Reference: Essex Trails Proposed Alignment

## **CRO Proposed Horizontal Alignment**

**FIGURE 1 ESSEX TRAILS - PROPOSED VT 289 PATH ALIGNMENT**

FIGURE 2

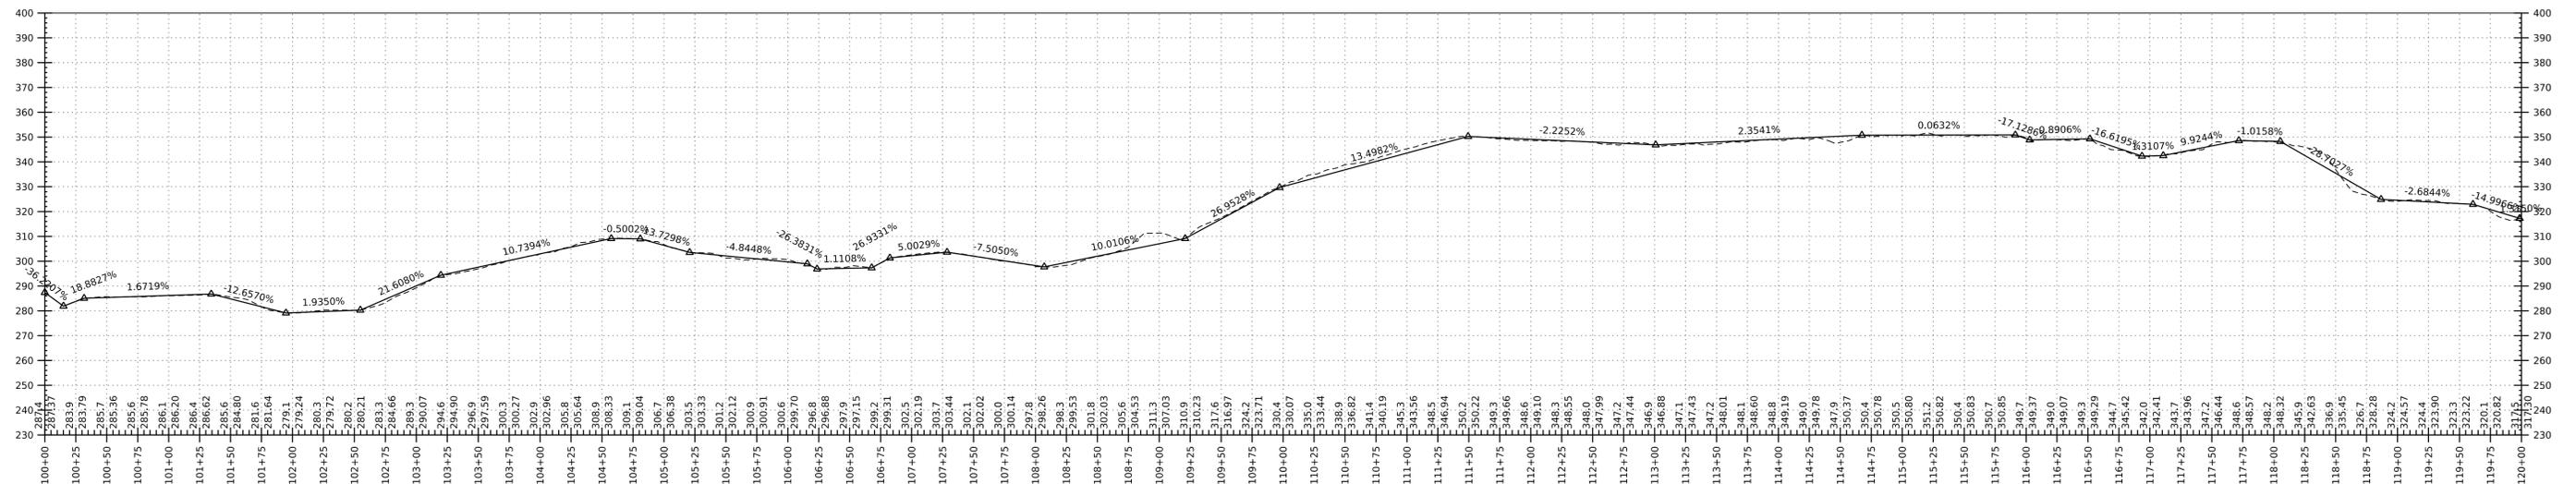
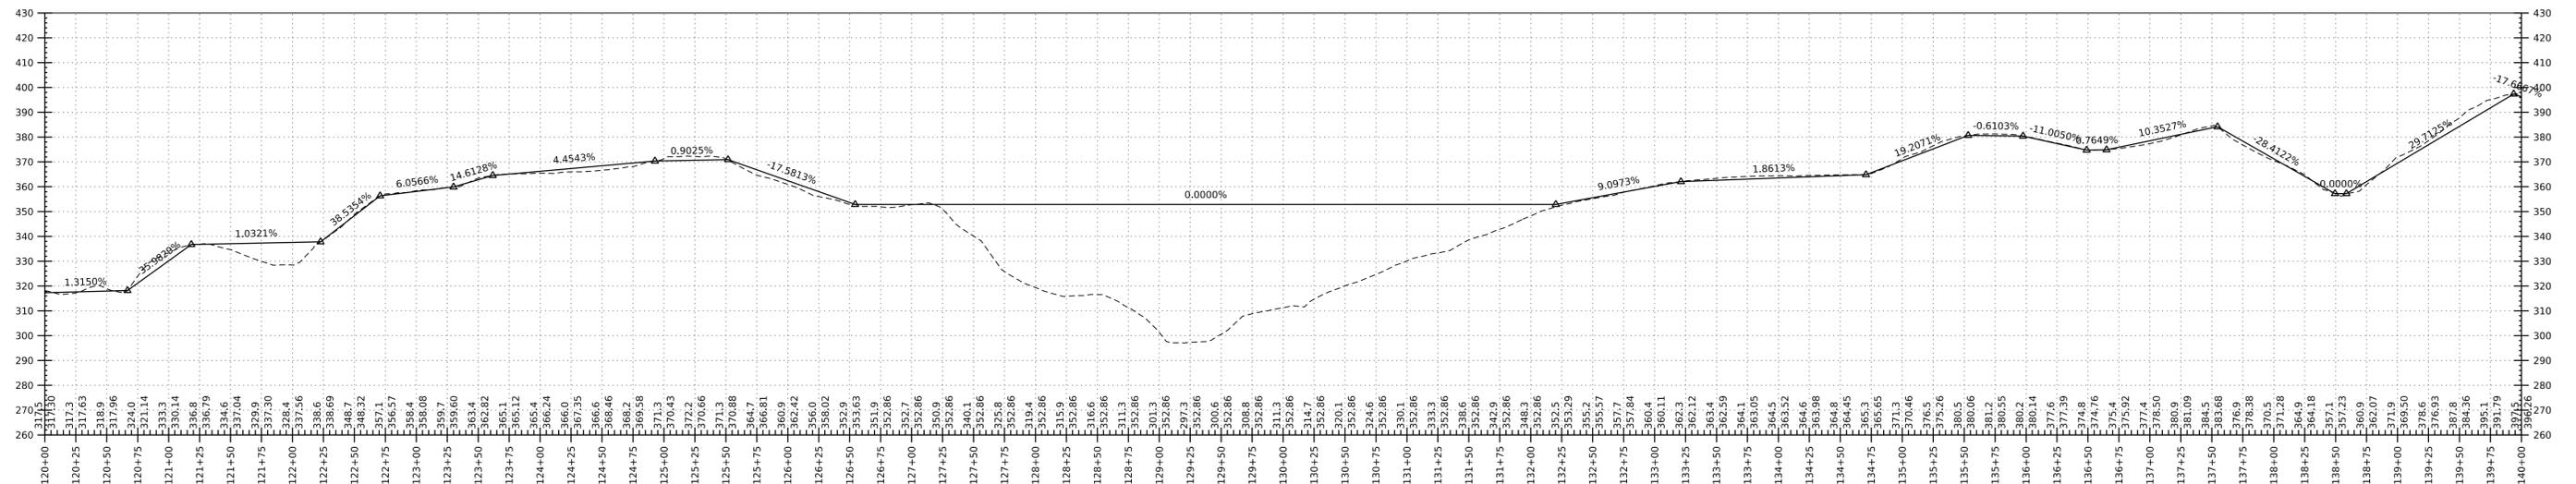
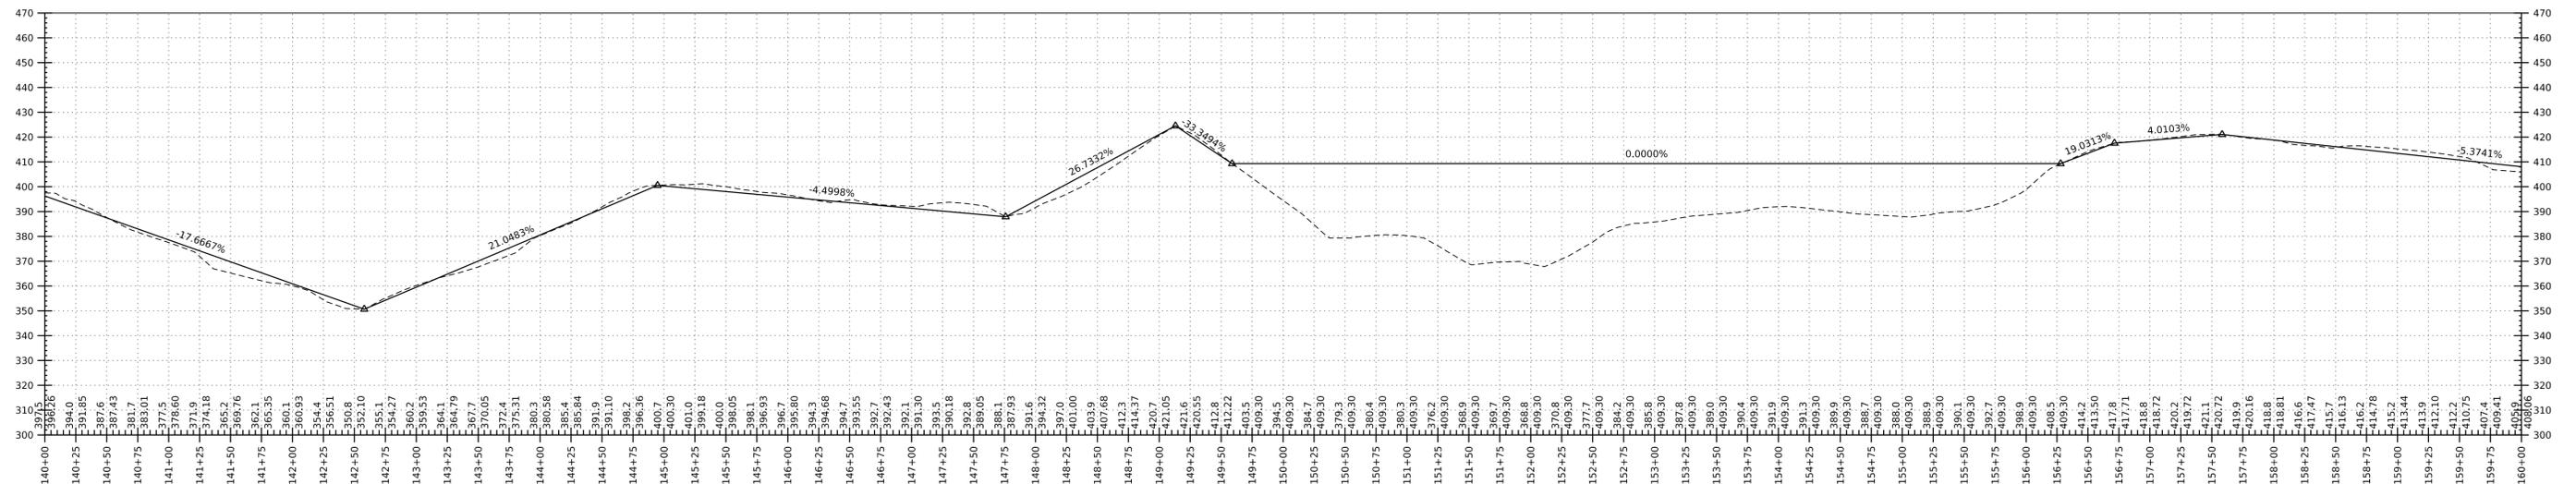
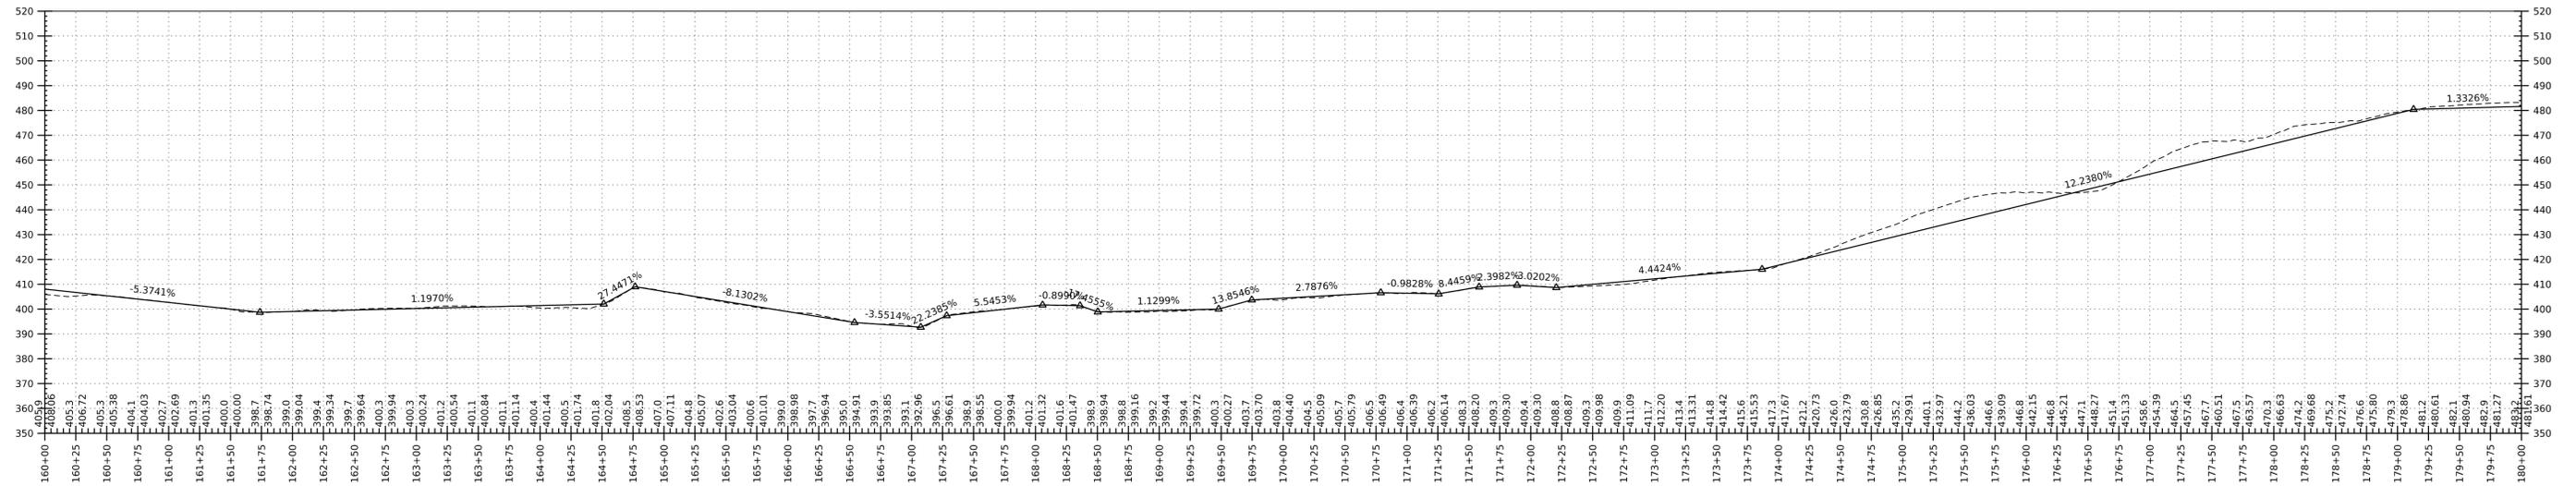
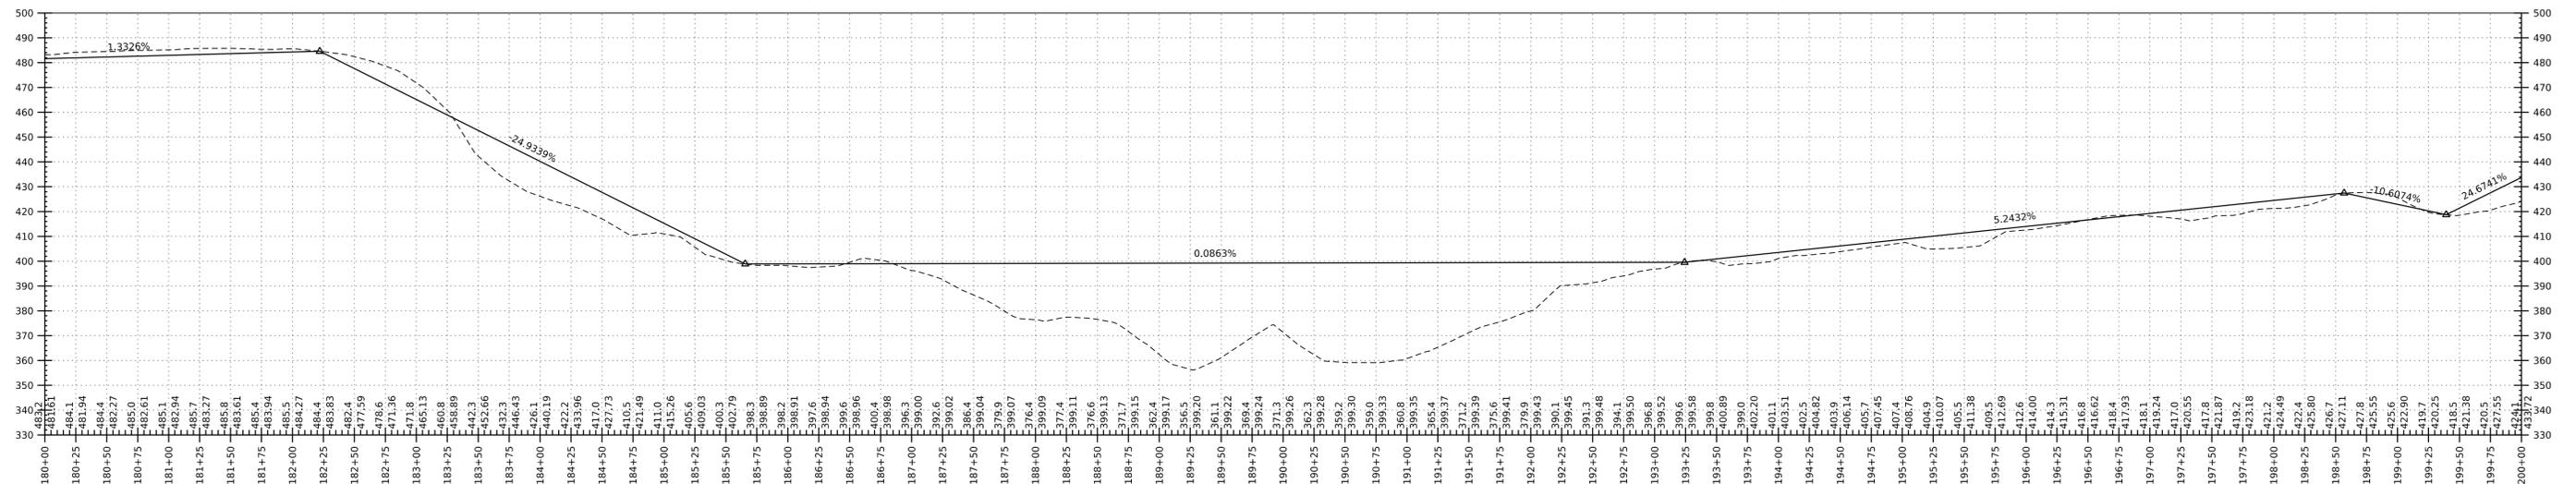
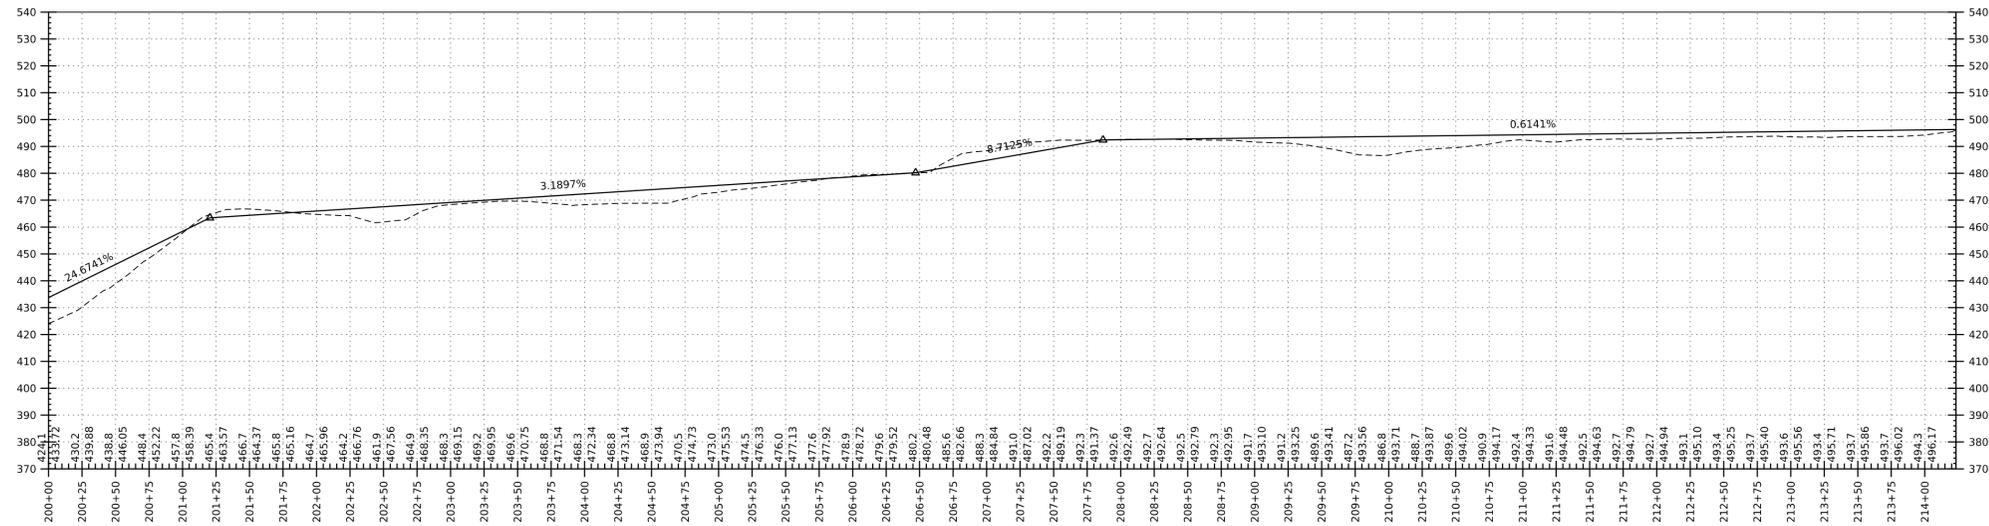
CRO's horizontal alignment and the revised horizontal alignments prepared by Stantec, along with general comments can be seen on Figure 1 (attached). The corresponding profile along existing ground can be seen in Figure 2 (attached). In general, the CRO alignment crosses steep segments, exceeding 12%, the maximum allowed by VT 289 design specifications. A majority of the grades exceed the desired average 5% grade, with some grades exceeding 20%. It crosses Alder Brook at multiple locations, which would require pedestrian/bicycle bridges. It also crosses existing state right of way (ROW) at multiple locations.
